City of Woodland
Meeting Agenda
Planning Commission

2. Design Review for DR Horton; Adeline at Spring Lake

An application has been filed by DR Horton for consideration of Site Plan and Design Review for a residential project (*DR Horton: Adeline at Spring Lake*) on 12.4 acres (77 residential lots) within the R-8 zone of the Spring Lake Planning Area.

TO: MEMBERS OF THE PLANNING COMMISSION
DATE: February 1, 2018
ITEM #: 2.
SUBJECT: Design Review for DR Horton; Adeline at Spring Lake

L-2

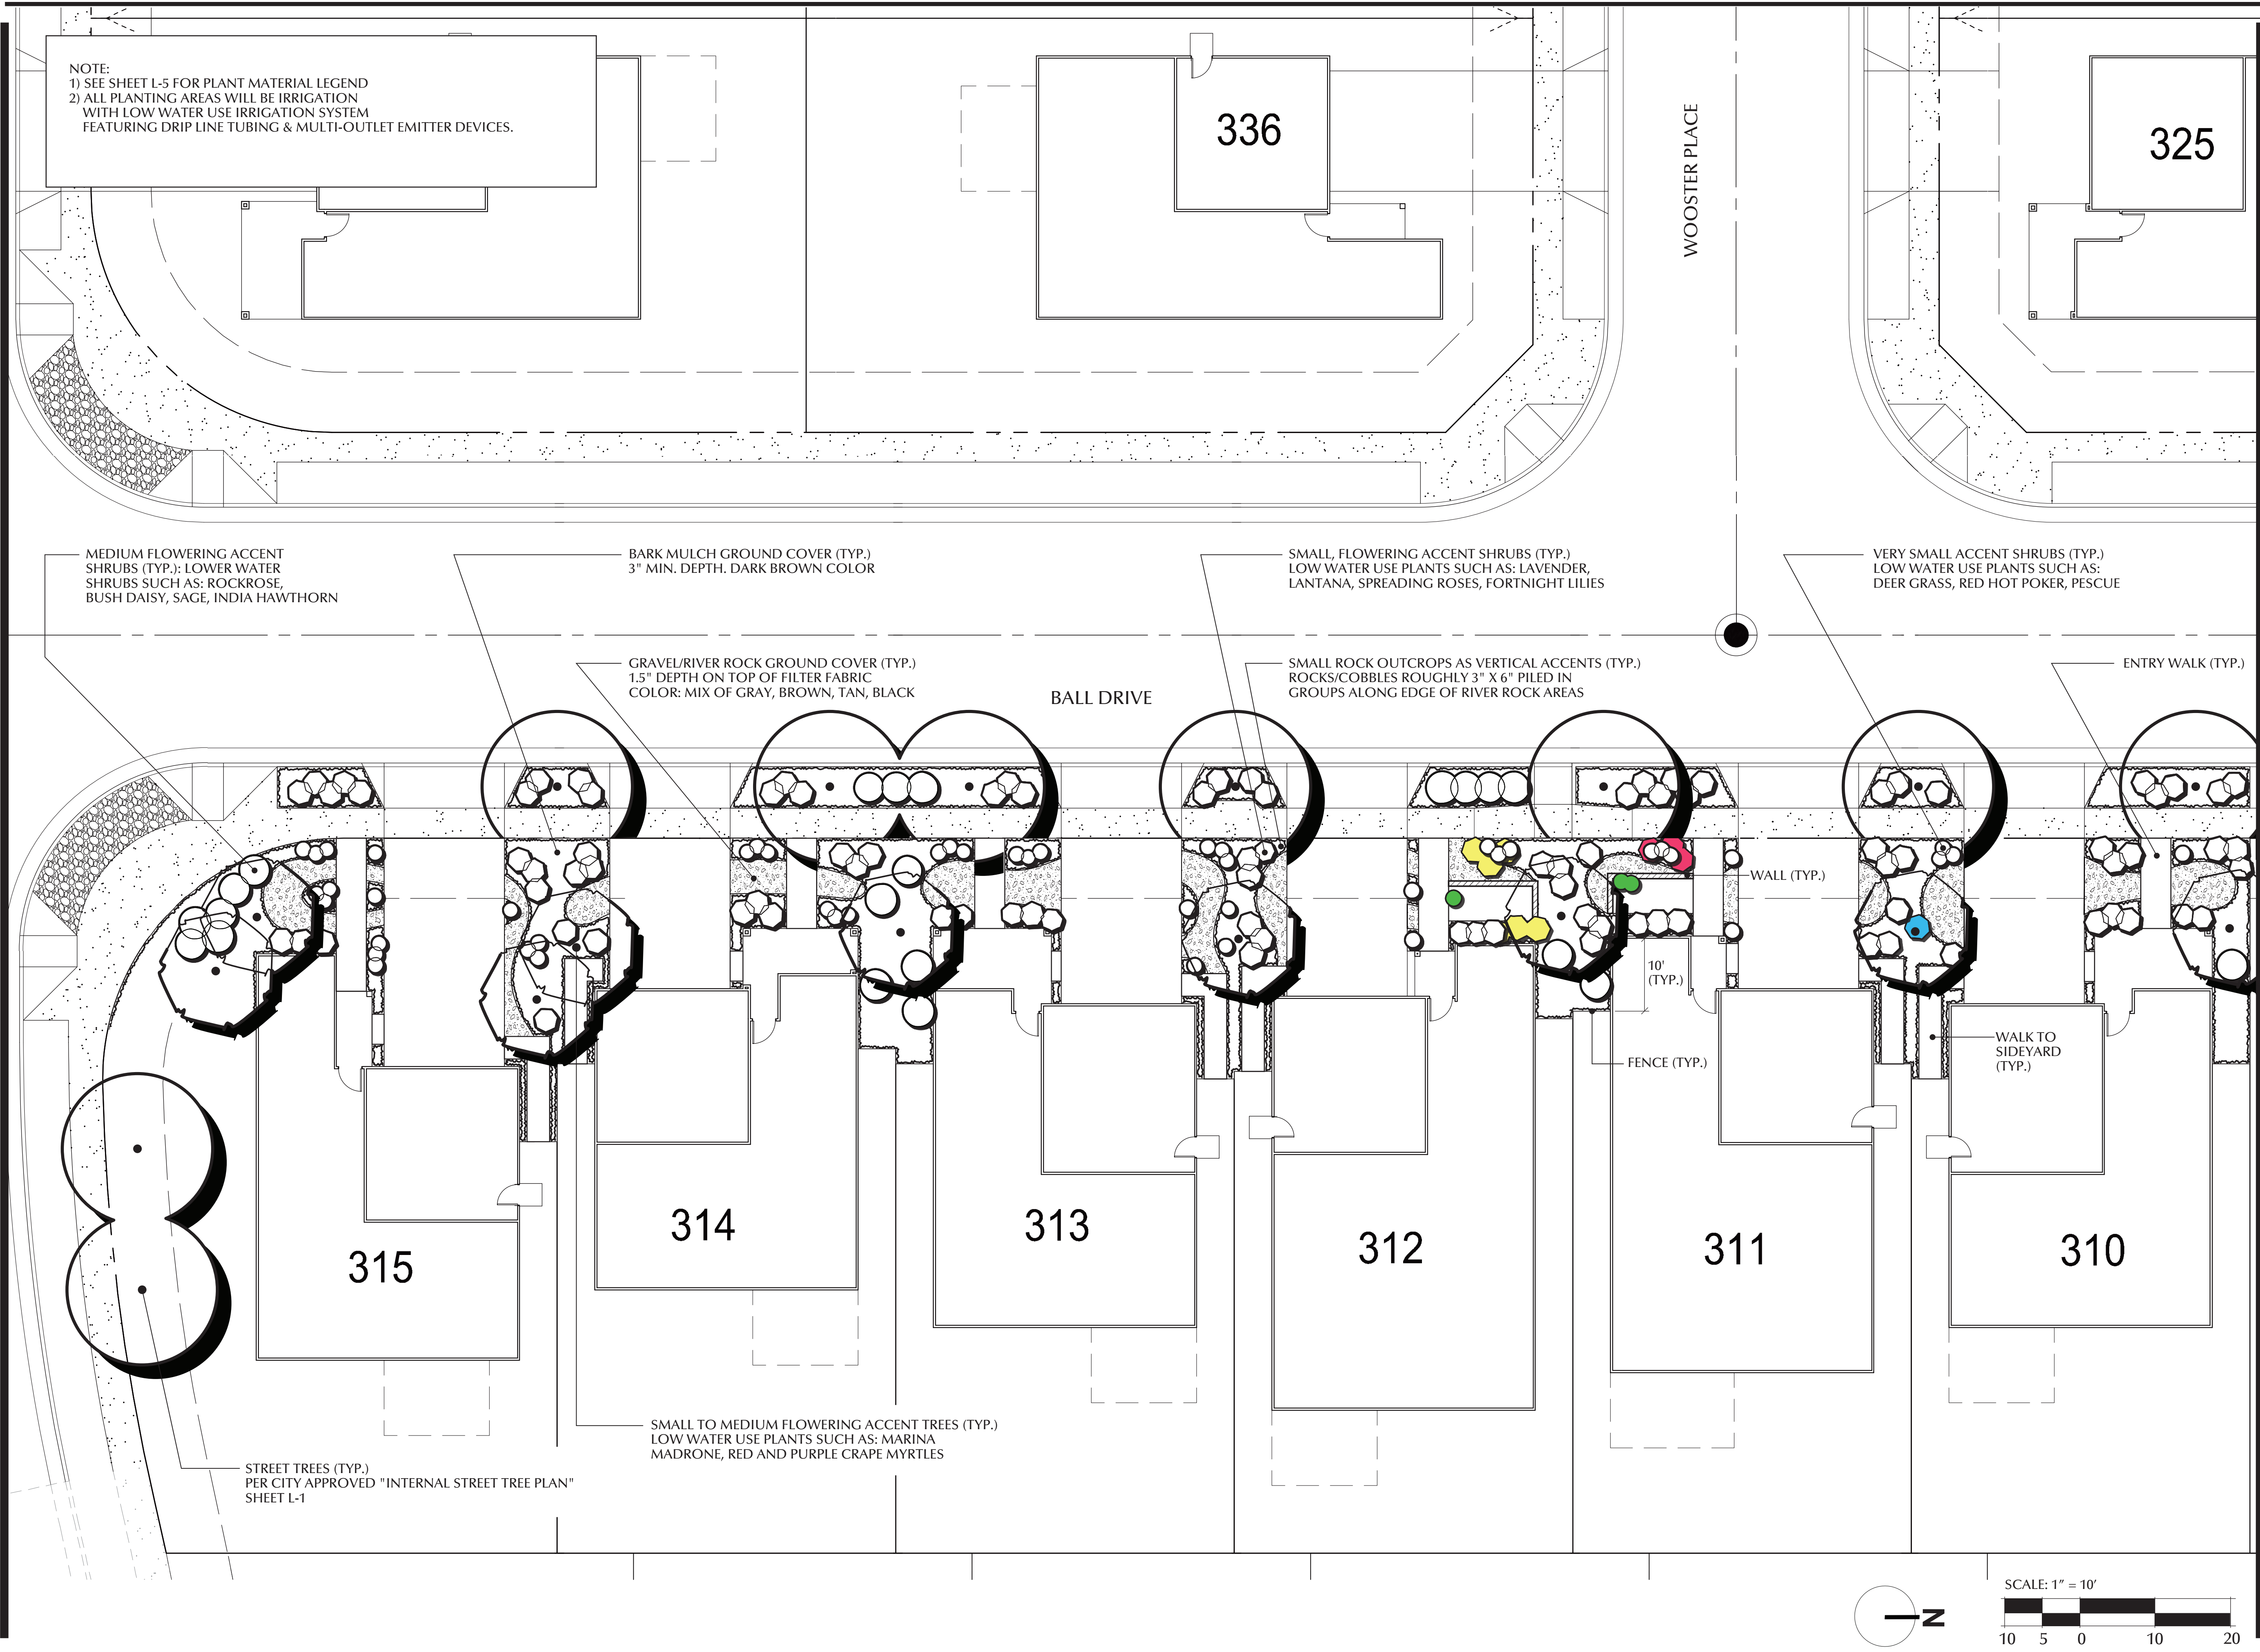
2. Preliminary Fencing Plan: Per City review comments, we modified our Preliminary Fencing Plan, Sheet L-2 to include; 1) a note to all wood details noting that the wood would be stained with a clear stain, and 2) a photo of a section of the existing wood fence at Arabella since this is the same fence per the details shown on our plans. As requested, these changes have been clouded with a note in the Revision block identifying the change with Delta No. 1, stating "Per City Review" with the date of 11/30/17.

2. PER CITY REVIEW
